Subject: Request for Amendment for the Model 927 Shipping Package

COMBUSTION ENGINEERING, INC. OUTLINE OF MODIFICATIONS TO THE DRAWINGS FOR 927 SHIPPING PACKAGES

Dimensional details of both containers are described in the licensing drawings [L-6078-01 Rev. 0, 927 Shipping Container (4 sheets)] provided on the following pages.

Figure 1A-1 Page 1-5

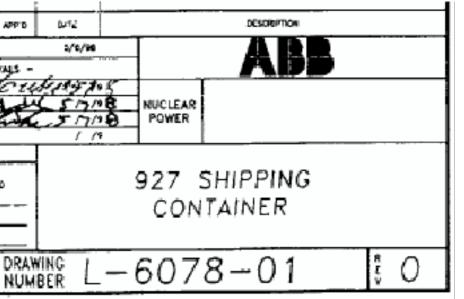
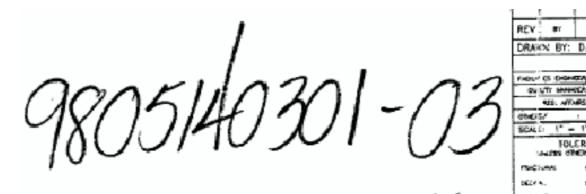
Zone A1

The independent holddown brackets shown in View D were not credited in the drop test as contributing to the retention of the fuel assemblies and are used for the loading and unloading process to retain the fuel assembly in place when the strongback cavity is raised to the vertical position. The dimensions and BOM callouts were removed and the wording was clarified to explicitly note that all 3 designs are optional.

Dimensional Tolerances have been added in the height and width of the upper and lower end fitting braces in View B. The dimensional tolerances are consistent with those proposed in View C for the strongback. The proposed tolerances on the height and width of the upper and lower end brackets does not impact the function of the brackets, it simply allows for slight variations in manufactured dimensions.

The side view shown in View B has been revised to be consistent with the actual configuration and show the alternate design of the upper and lower end brace center support bracket and lower support angle. The current licensed drawings show a single 2 inch by 4 inch tubular steel support brace in the center of the upper and lower end brace which is the correct configuration for the model 927C1, however, the model 927A1 packages have two 2 inch by 2 inch tubular steel braces welded together to form the 2 inch by 4 inch support. The model 927A1 design was the configuration which was actually drop tested. Although the information in Reference 1 and 2 does not supply detail on the specific item, photographs of the drop test show the welded double tubular steel support.

The lifting trunion shown in View F was removed, since it pertains to loading and unloading of the package only.

View G-G was also removed since the locator pins were labeled as optional on Sheet 1 and serve only to align the upper shell with the lower shell during loading and unloading of the package.

View C was modified to include dimensional tolerances on the width and height. The current criticality safety analysis bounds this increase in width dimensions and is also covered in the vertical direction by allowing a maximum assembly height above the separator block of 1.5 inches. Other dimensions were listed as reference dimensions.

The weld locations were made less specific and the amount of minimum weld has been reduced to 10 inches. The justification for this is reduction in minimum weld length is provided in the attached revised page 2B-12 of the application.

An optional tapered end cut was added to View A and the optional angle bracket designs which secure the strongback to the bridge supports were moved to Sheet 4 and further detail was added to distinguish the differences between the Model A and Model C designs. An additional view was added to show the different orientation of the lower channel support which holds the shock mount. The Model A packages have the new outward facing channel orientation, whereas the current drawings only show the Model C inward facing orientation.

Figure 1A-1 Page 1-6

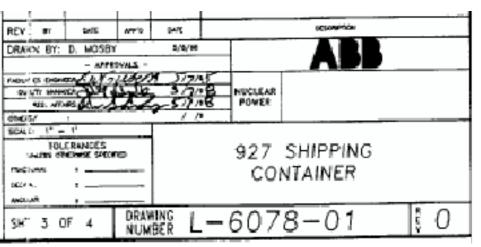
Zone A1 View B-B was removed.

Items (5), (6) and (11) were called out on the upper shell and replaced the dimensional description.

An option was included for the inclusion of an optional protective flange cover or coating to help reduce the amount of environmental exposure to the flange surface.

Item (66) was also added as an optional protective wear plate around each T-bolt area. The wear plates would be either riveted or tack welded in place and would function to facilitate opening and closing of the container as well as protection of the flange surface.

The details describing the mounting bracket and View A-A have been removed from the drawings. This view provided details on the trunnion used for lifting the strongback to it's vertical position during the loading and unloading process.

A butt weld designation has been added to the upper and lower portions of the shell to be in agreement with the actual configuration. The weld location varies between packages and was part of the original design of each model. Please refer to the information in Zone C2 of Sheet 1.

The information in these zones have been added for this amendment and focus on the welding repair specifications and standards required for weld repair. This information is also contained in the Revision to Section 8.0 of the Certificate of Compliance application.
